GPU Nuclear Corporation

May 31, 1984
5211-84-2125

Three Mile Island Nuclear Station, Unit 1 (TMI-1)
Operating License NO. DPR-50
Docket No. 50-289
Seismic Capability of Backup Thermocouple Reading
And Display System

Response to NRC comments on TMI-1 Seismic capability of backup thermocouple reading and display system.

Figure #1 Response Spectras Used to Qualify Foxboro
NZES Signal Conditioning Rack at TMI-1

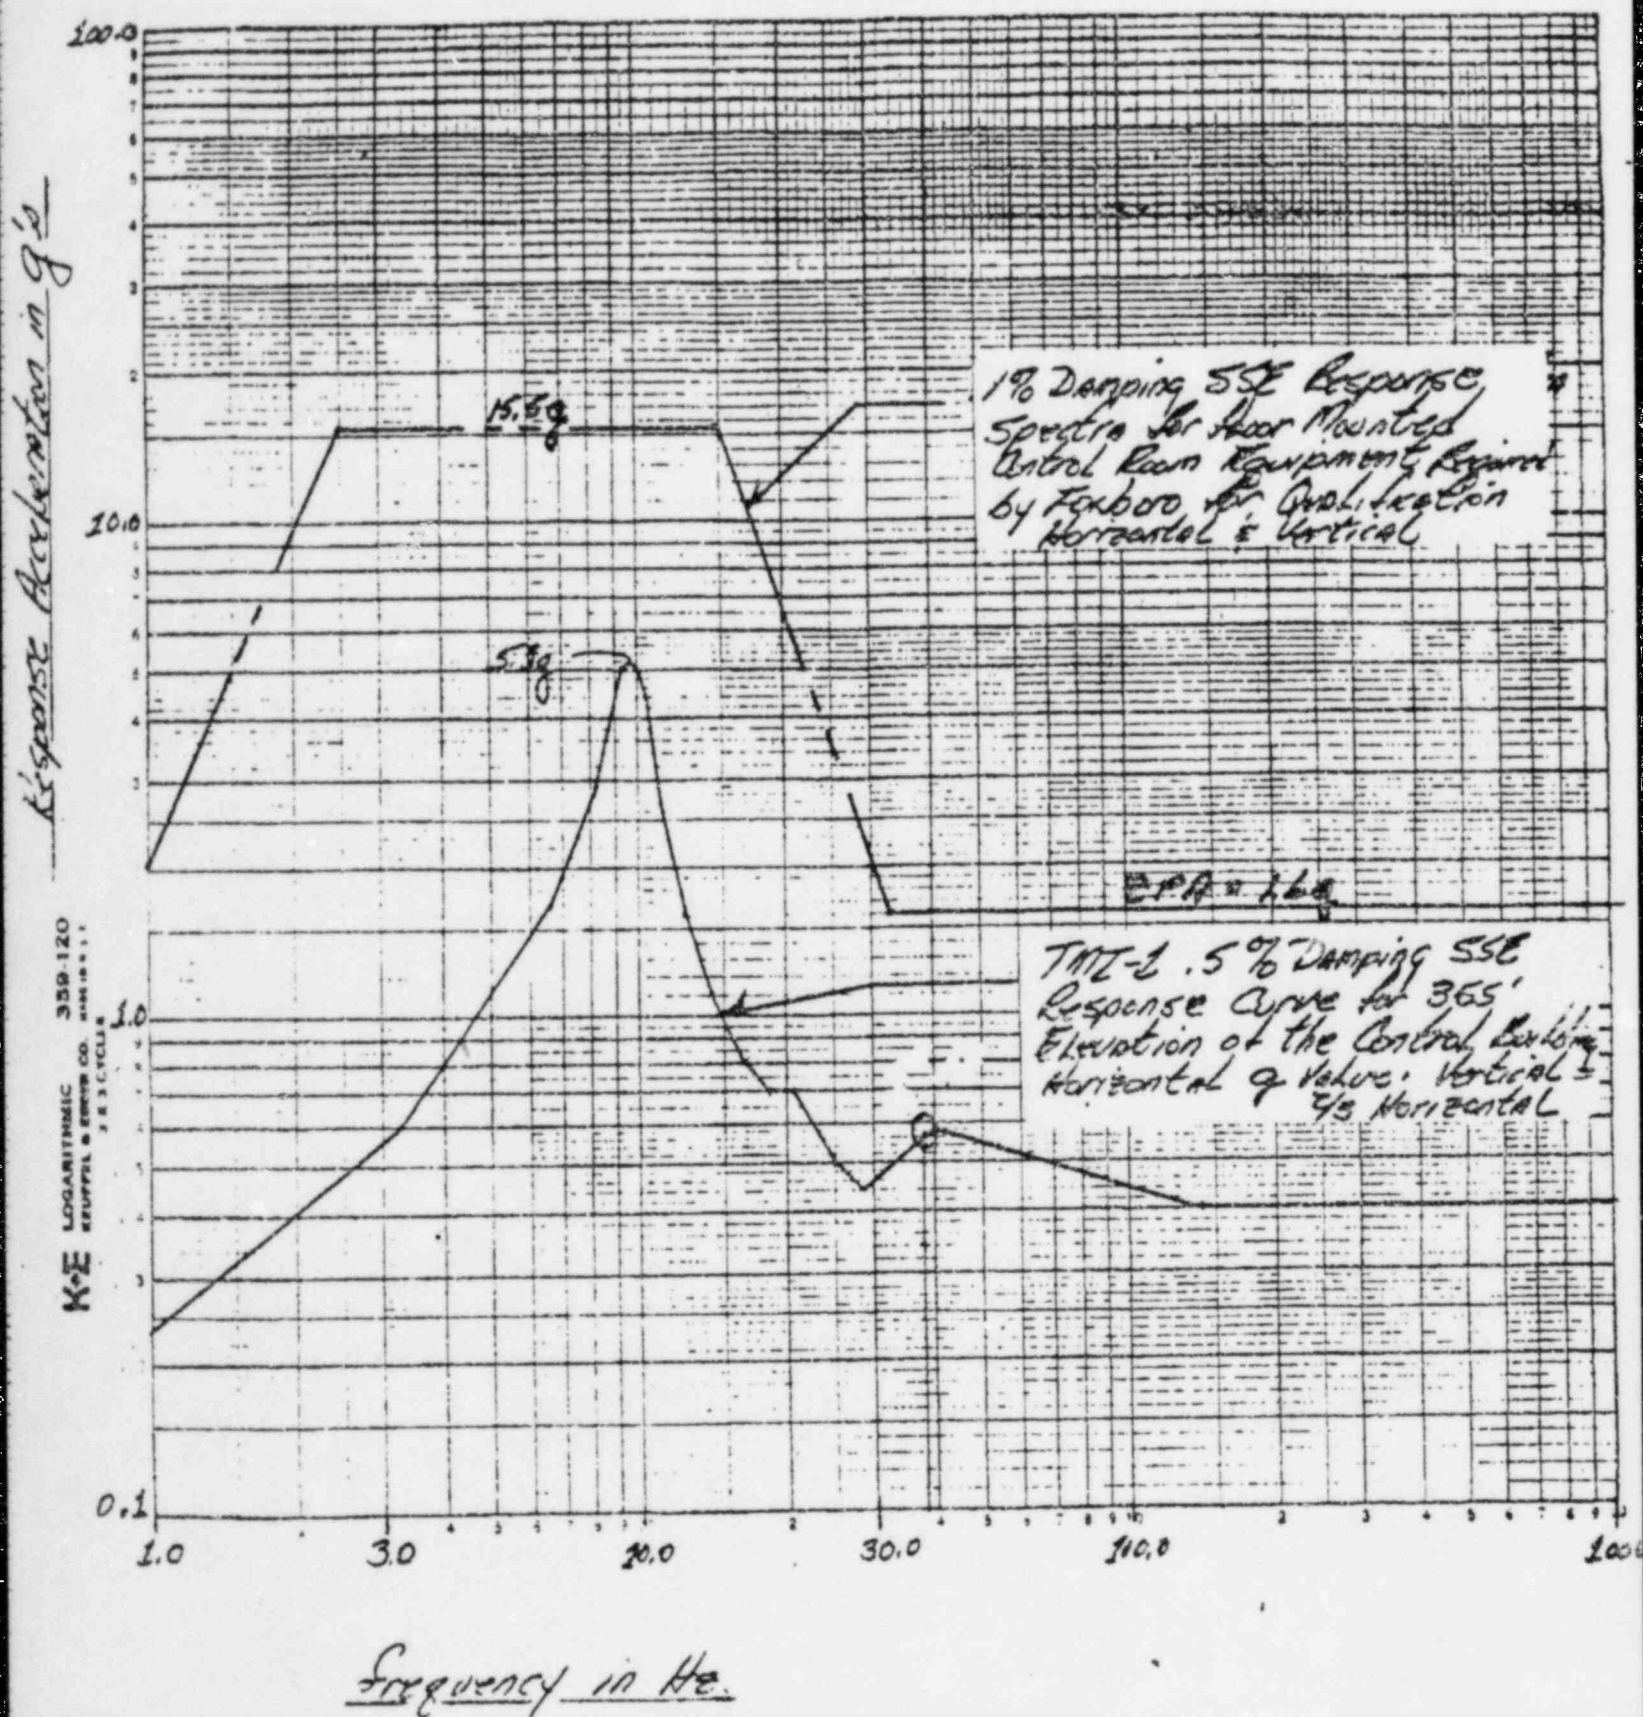
Comment #3: Demonstrate that the signal conditioning unit including its contents has adequate seismic capability.

The associated G values based on the TMI-1 response curve in figure #1, for the as installed Foxboro rack are:

The above results indicate that all modal frequencies are above 33Hz. It is well known that components with modal frequencies above 33Hz will respond as rigid bodies during an earthquake, i.e., the dynamic amplification is unity. Consequently, the component can be analyzed in a static manner and transfer functions are such that the response of the component does not show amplification due to the dynamic input.

The qualification response spectrum used by Foxboro for the test of N2E5 racks (installed at TMI) is depicted in the attached figure. The TMI-1 SSE response spectrum for the floor where the rack is installed is also shown in the same figure. It should be noted that the former envelopes the TMI-1 spectrum by at least a factor of 3. Furthermore, during testing, the horizontal and vertical components of the curves were assumed equal and applied simultaneously. In the TMI-1 FSAR, the vertical acceleration is only 2/3 of the horizontal acceleration.

It is GPUN's conclusion that the subject rack (N2E5) is seismically qualified, i.e. it should maintain its structural integrity and remain functional during and after a SSE Event.

SECTION A-A

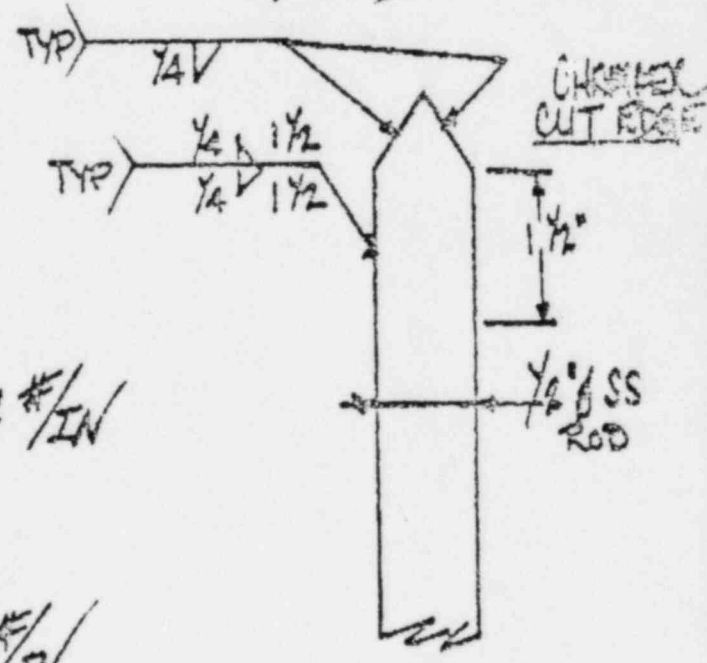
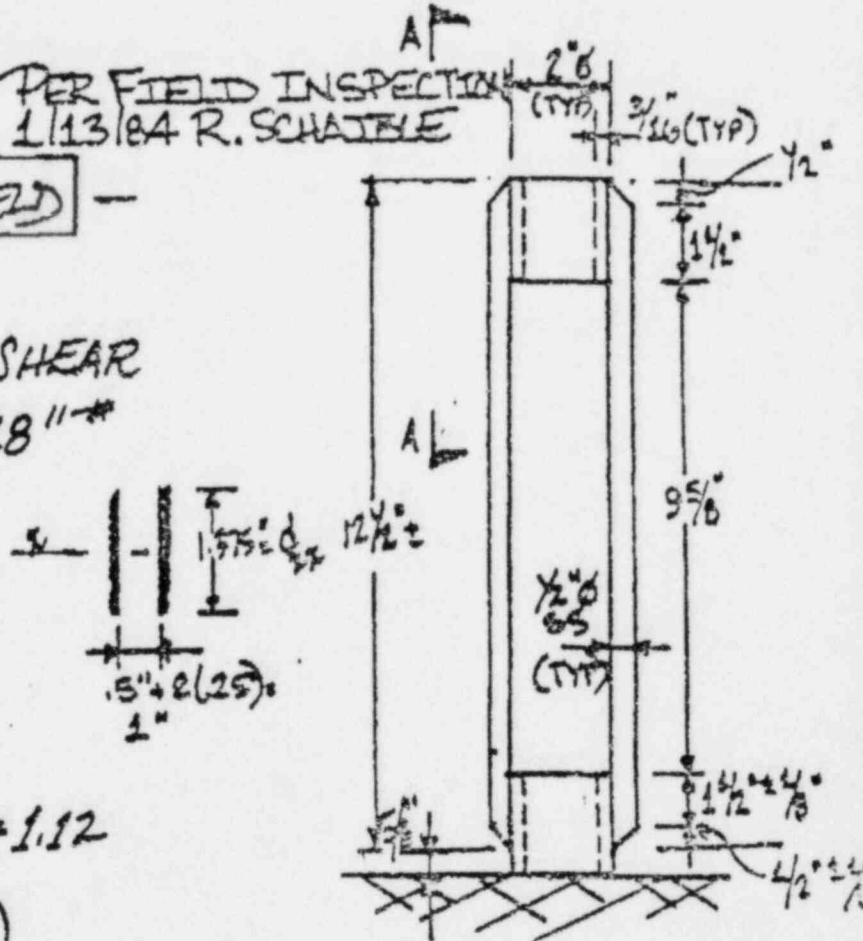
Comment #4: Demonstrate that the welded connections for the thermocouple lead cable sleeves have the required strength.

Response: The cable sleeve to the seal plate welds have been analyzed and added to the subject document (Calc. #C-1101-625-5320-001, rev. 1). This analysis indicates the welds are capable of withstanding the seismic event (SSE), without loss of structural integrity or safety function, and is attached. The two 1/2 in. diameter bars connecting the cable sleeve to the seal plate are detailed in the aforementioned calculations. A copy of the above referenced calculation is included as Attachment 4.

$\therefore f_T = \frac{118 \text{ in}^4 (1.375/2)}{1.12} = 72.4 \text{ #/IN}$

$f_B = \frac{M_B}{S_W} = \frac{9.37 \text{ in}^4 (12.5")}{.63} = 186 \text{ #/IN}$

$$\therefore 262\#/\text{IN} < 3288\#/\text{IN} \quad \text{OK}$$
